Version 4

2018-20 Accord: Rear Tray Rattles

Supersedes 19-044, dated April 23, 2019, to revise the information highlighted in yellow.

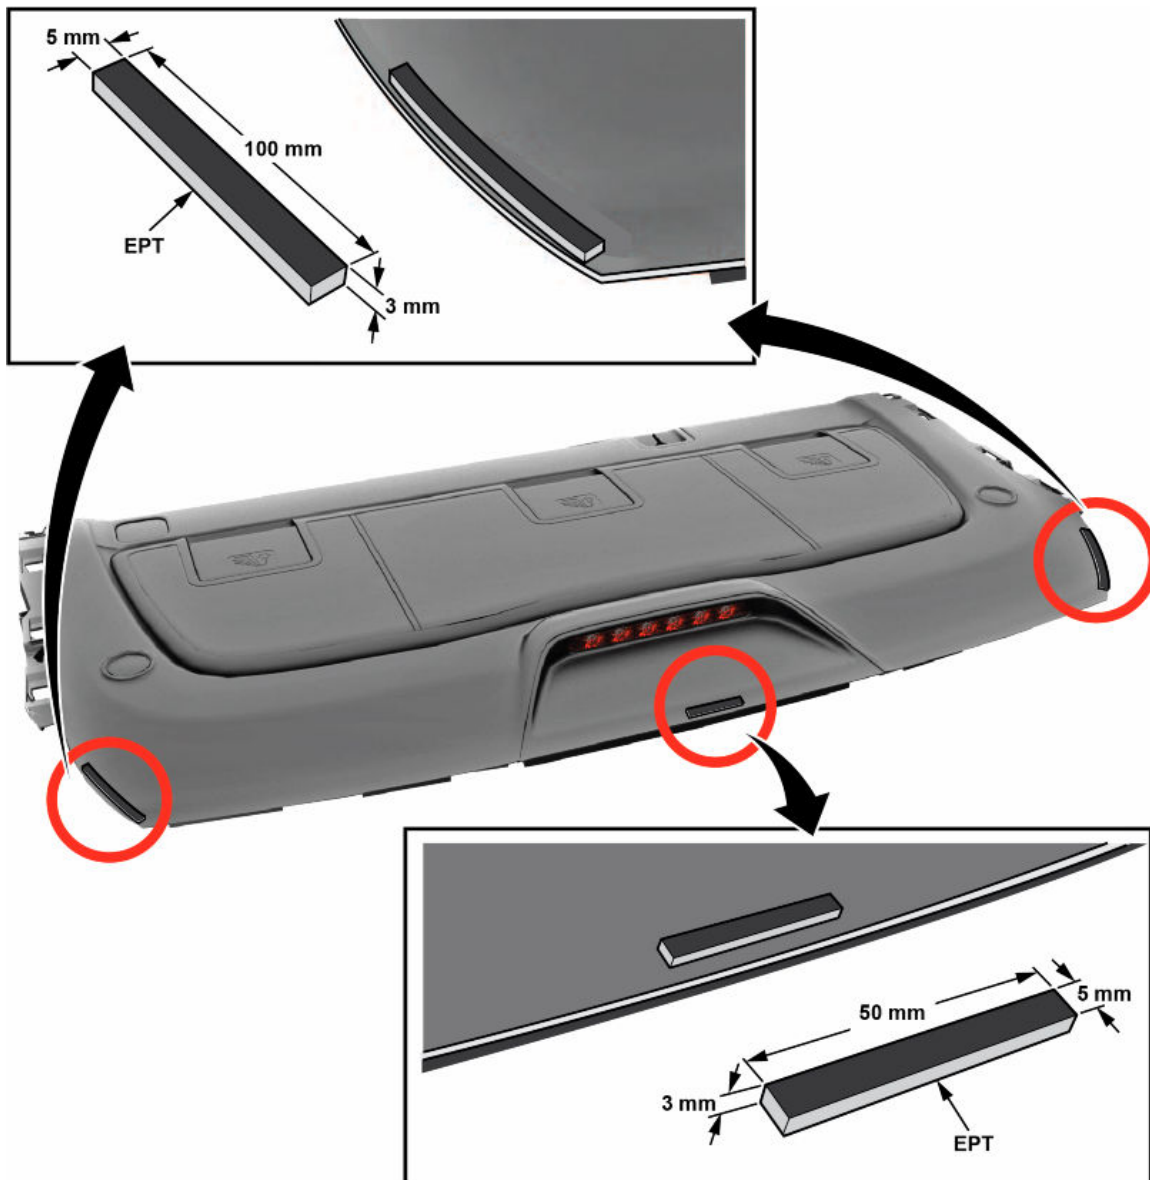
7. Cut two pieces of EPT foam 5 mm X 100 mm and 5 mm X 50 mm as shown below.

8. Clean the surface of the rear shelf where the EPT foam will be attached. Then, attach the EPT foam as shown.

NOTE: Make sure to center the EPT foam when applying to the tray.

Apply a 5 mm X 100 mm piece of EPT foam to each back corner and 5 mm X 50 mm to the middle of the rear tray.
